**Re: Lonza Biologics – Proposed Industrial Development
Traffic Peer Review Response 2
Supplemental PB Submission – Amended Site Plan Review Application**

PROPOSED INDUSTRIAL DEVELOPMENT

70 & 80 CORPORATE DRIVE PORTSMOUTH, NEW HAMPSHIRE

LAST REVISED: NOVEMBER 9, 2023

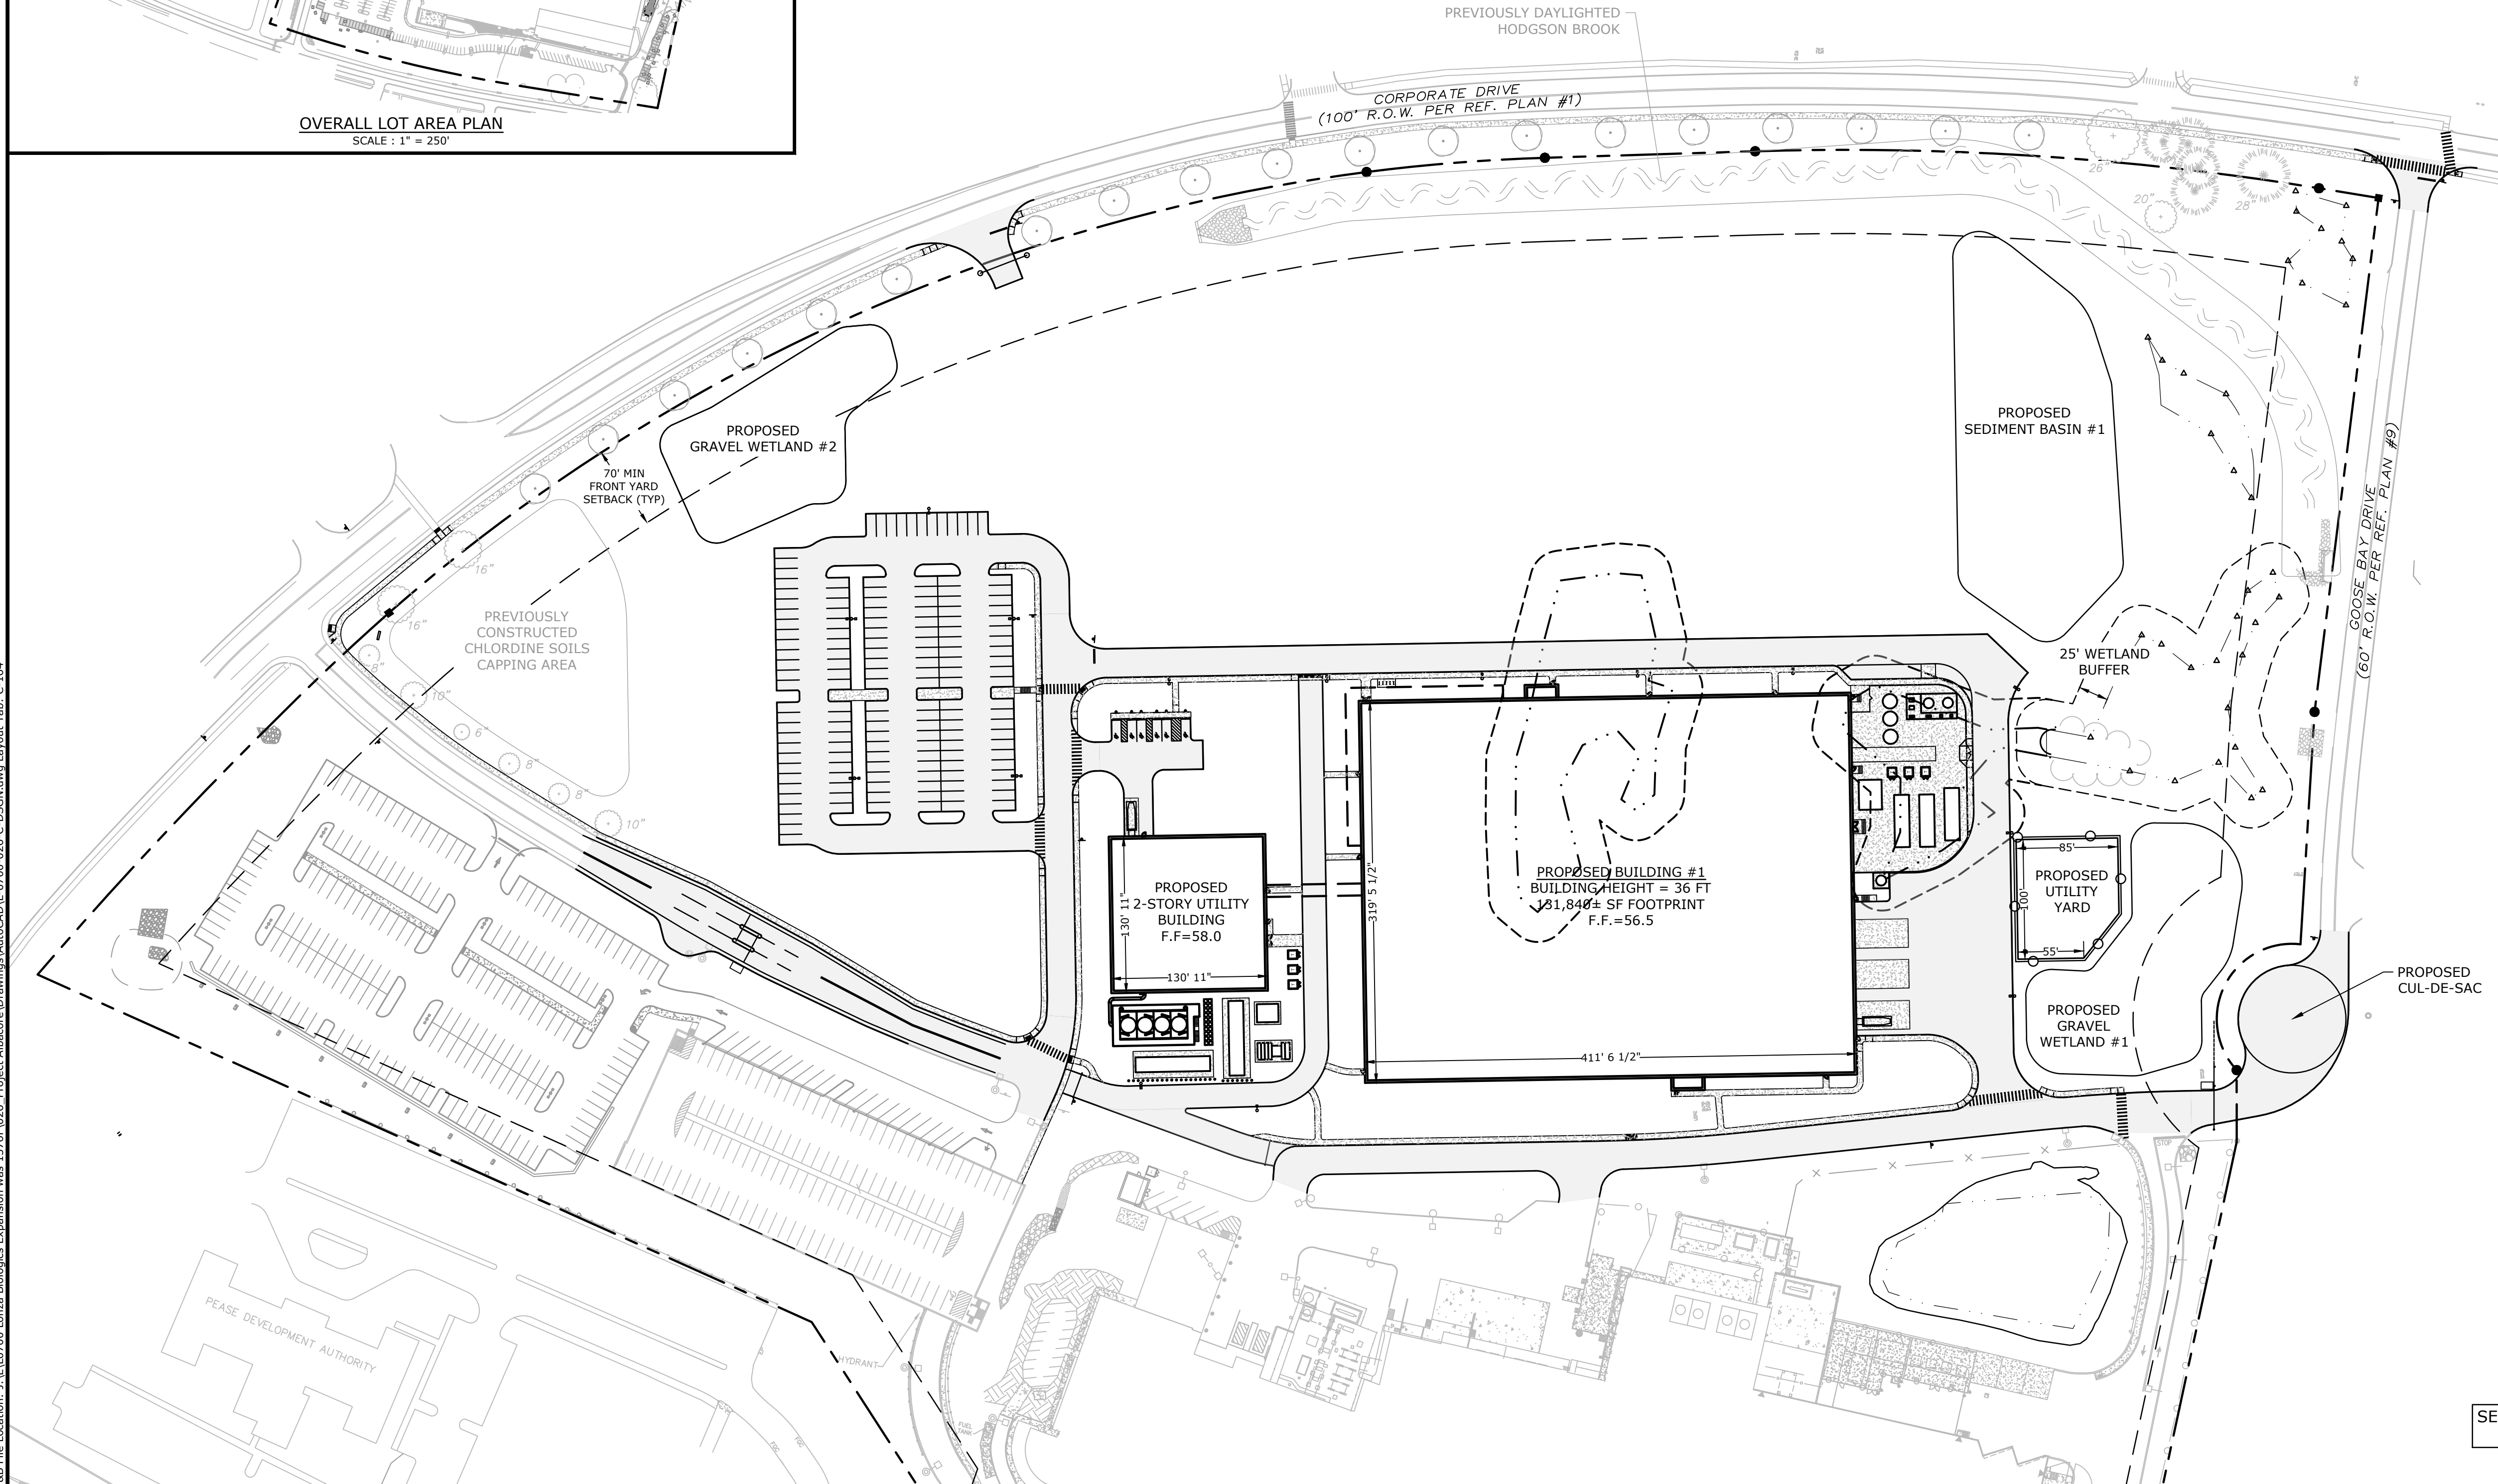
Response: **The parking requirement for this site is 2 spaces per 3 employees during the largest shift based on the current PDA Land Use Controls. Based on this requirement and the existing and proposed employee counts, 1,326 spaces are required. 1,501 spaces will be provided as part of the project (801 existing parking spaces plus 700 proposed garage parking spaces) as indicated on Sheet C-104. The parking requirement for Phase 2 of the project is 880 spaces where 957 spaces will be provided (801 existing parking spaces plus 150 surface parking spaces) as indicated on Sheet C-164.**

C-165

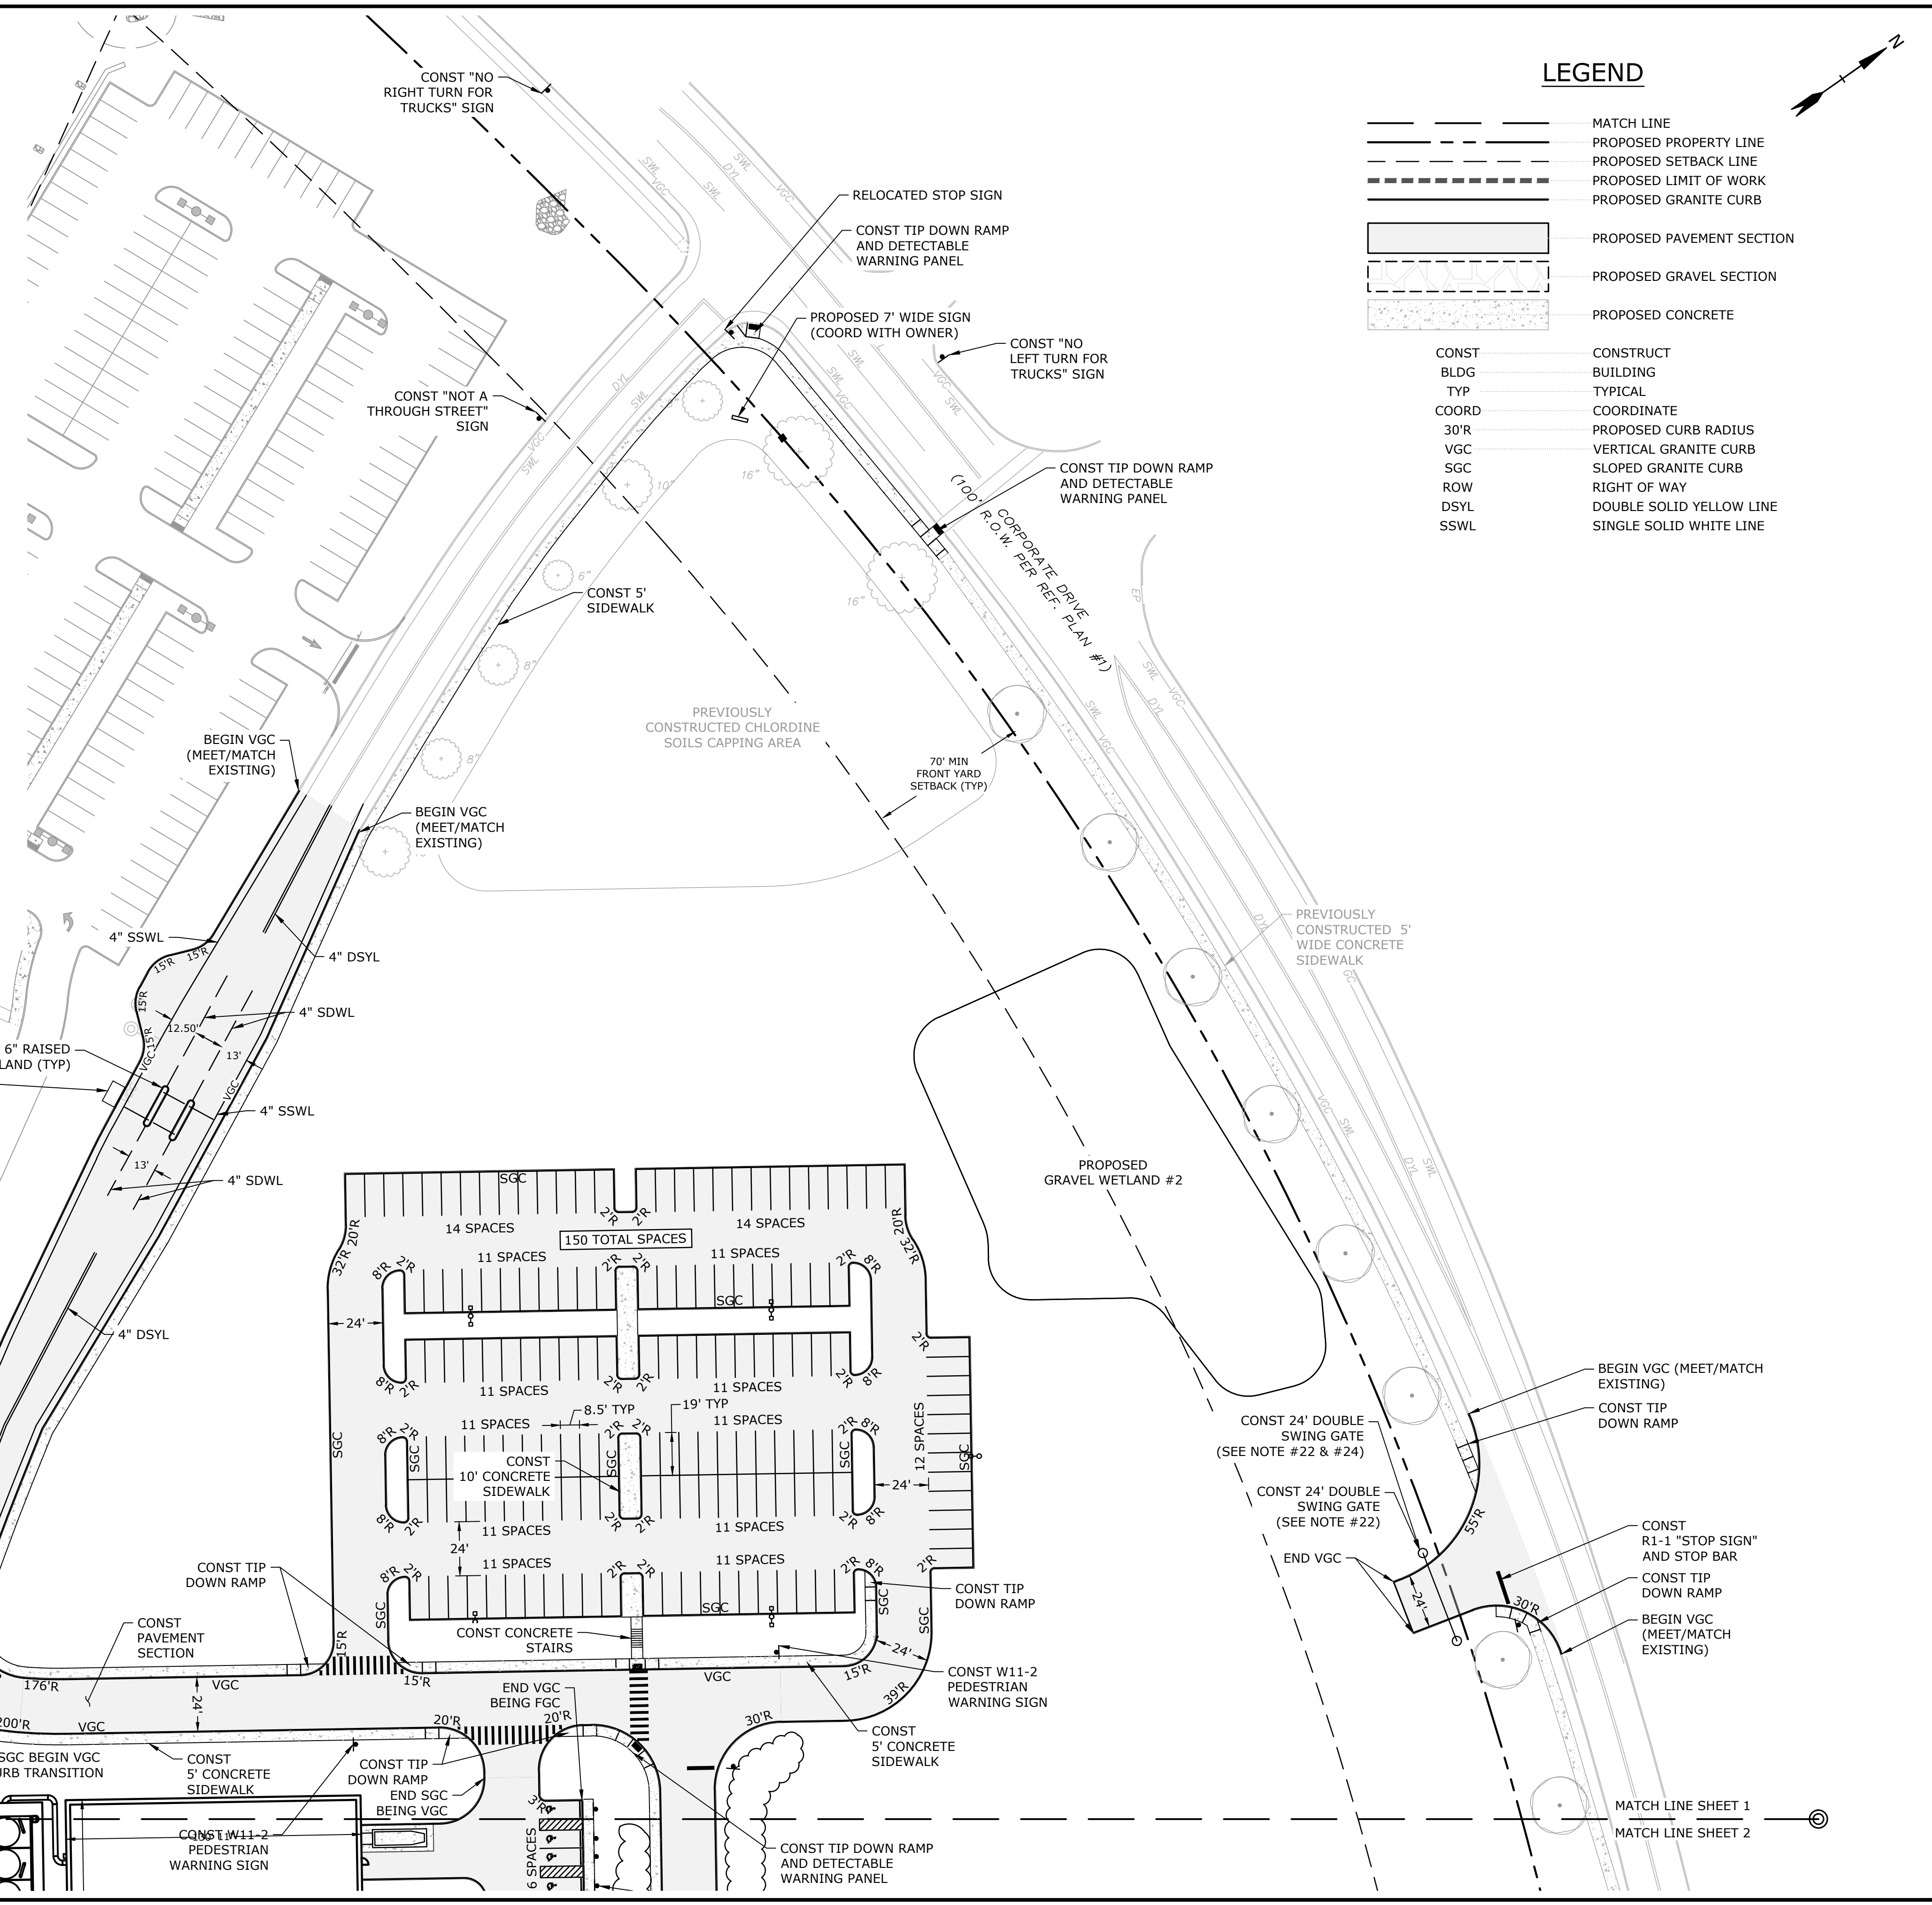
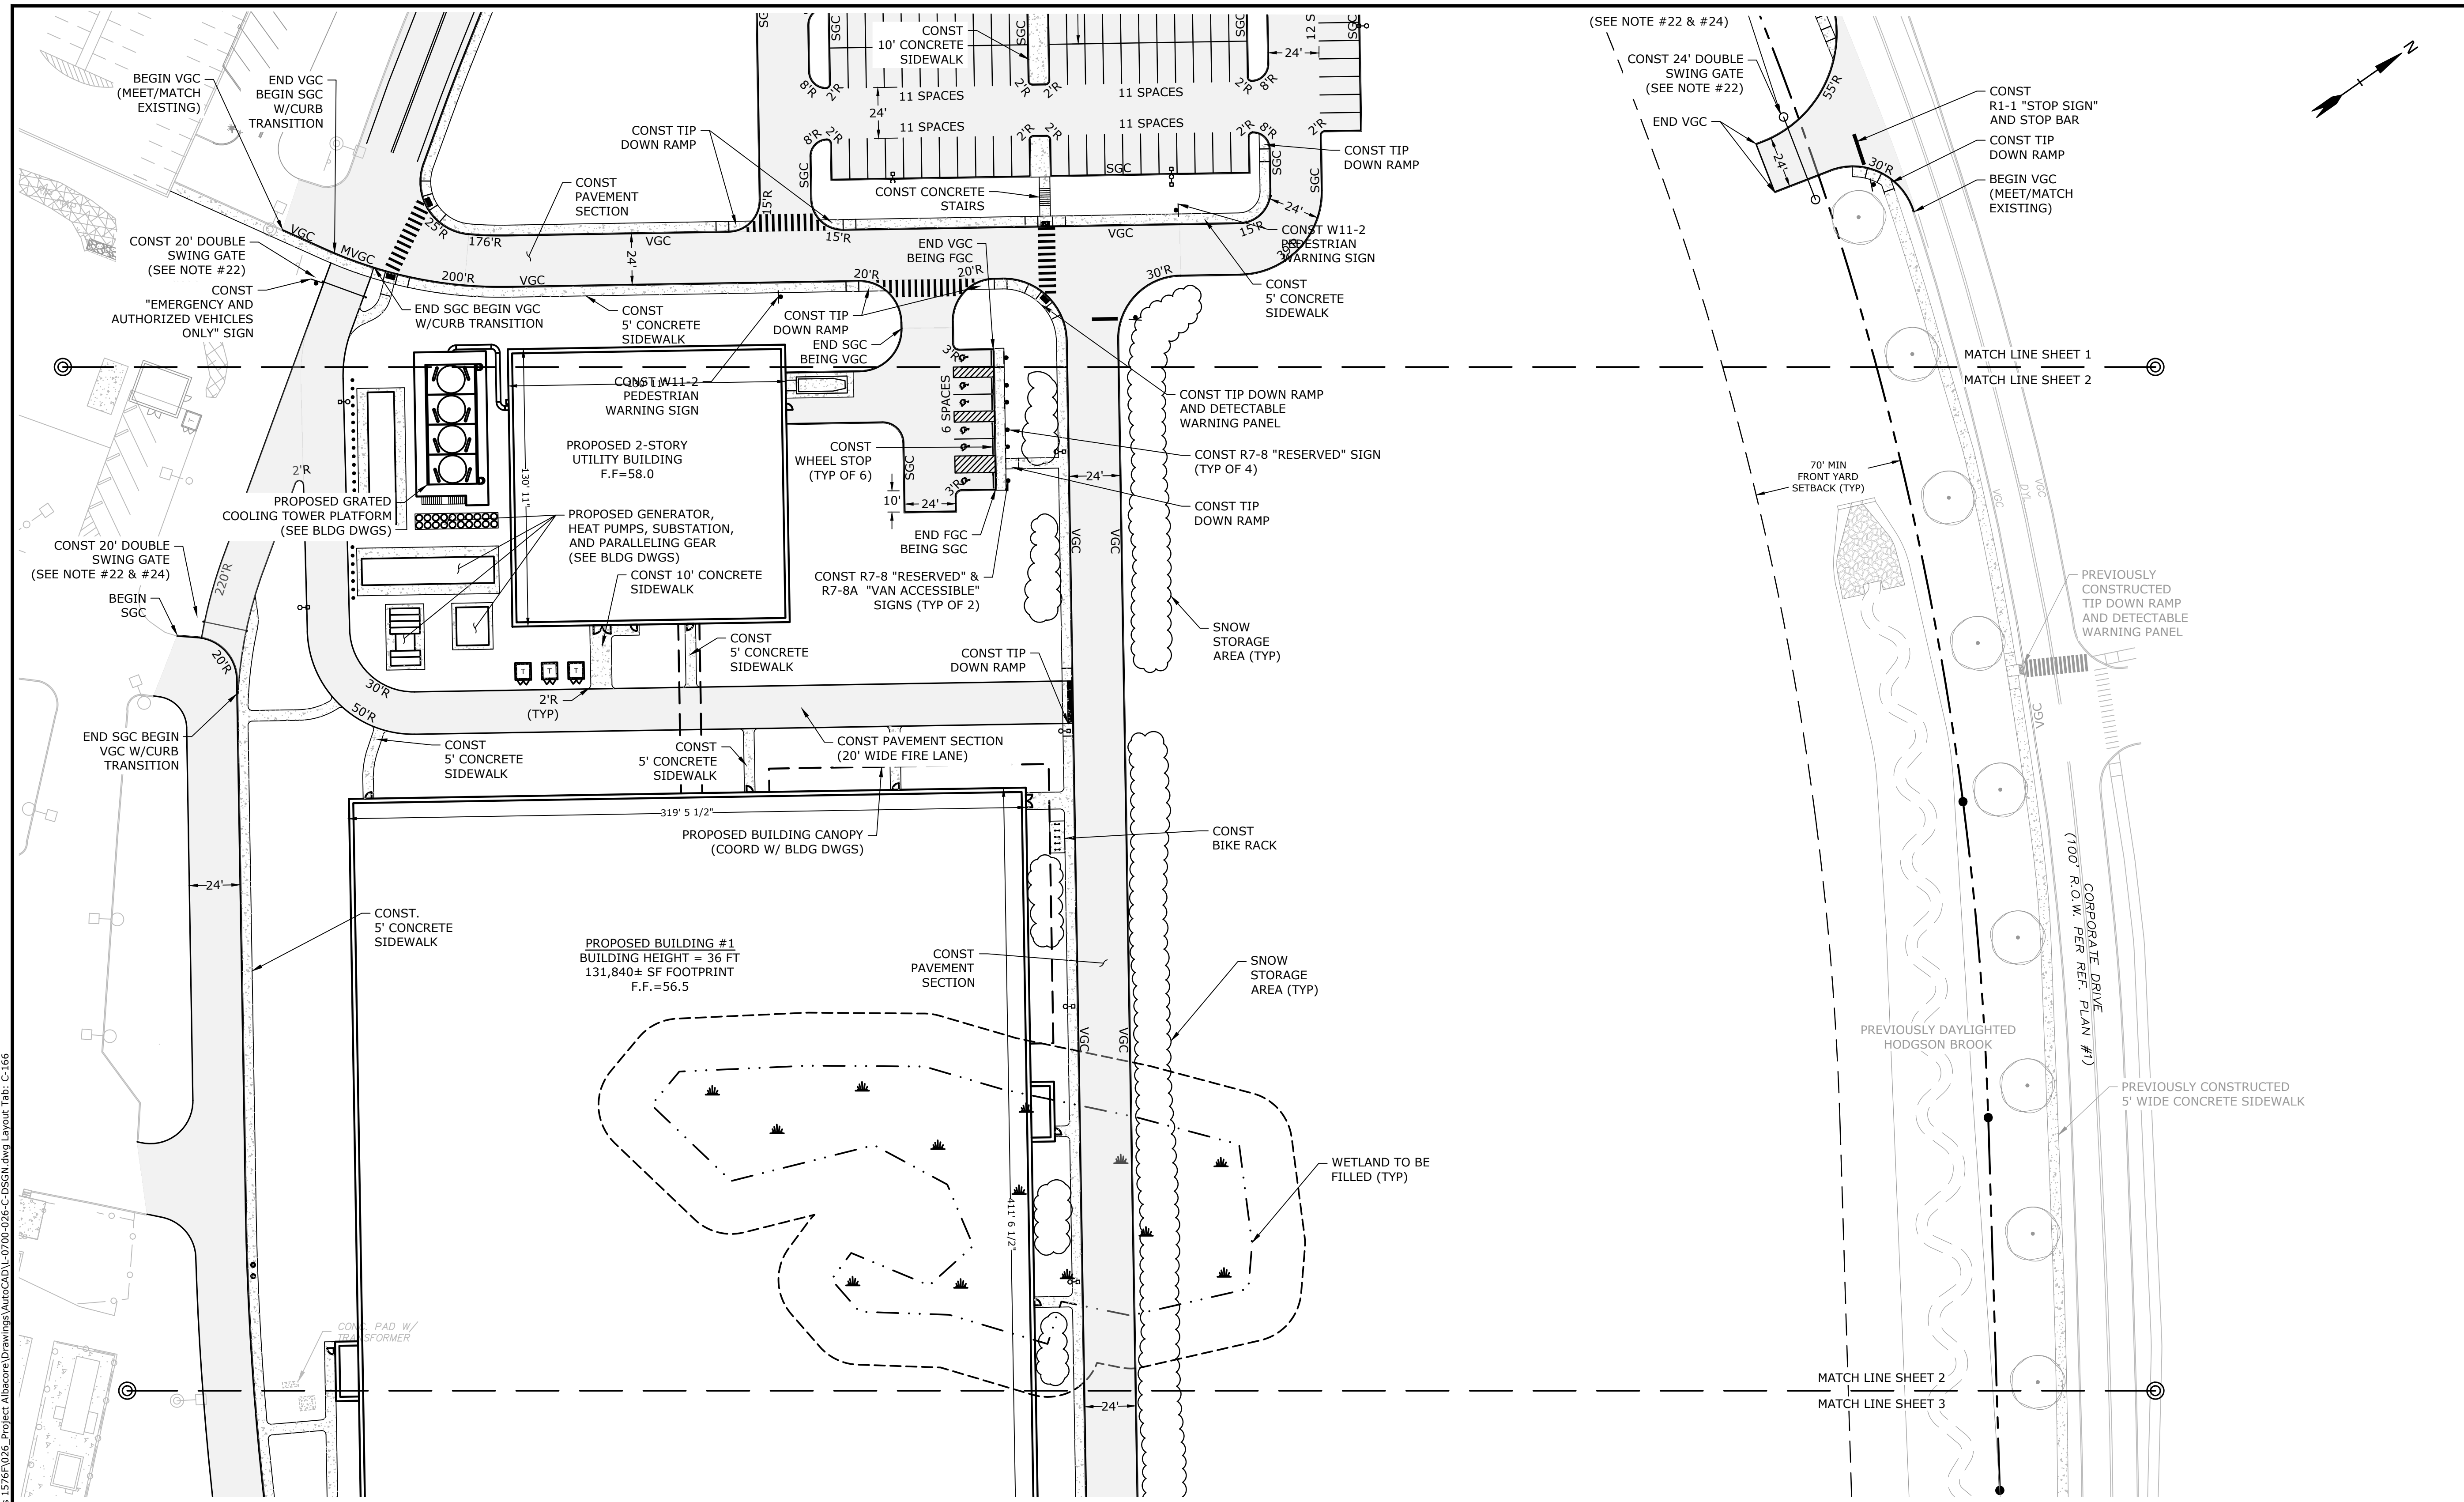
- A central sidewalk has been added through the 150 space parking area connecting to the currently proposed sidewalk. (Sheet C-165)
- A second trash compactor has been added to the site adjacent to the Utility Building. Truck turning was studied to confirm access. (Sheet C-166)
- Pedestrian warning signs have been added to the plans as recommended. (Sheets C-165, C-167 & C-502)
- Crosswalk Striping detail has been revised to note an 8' width. (Sheet C-502)
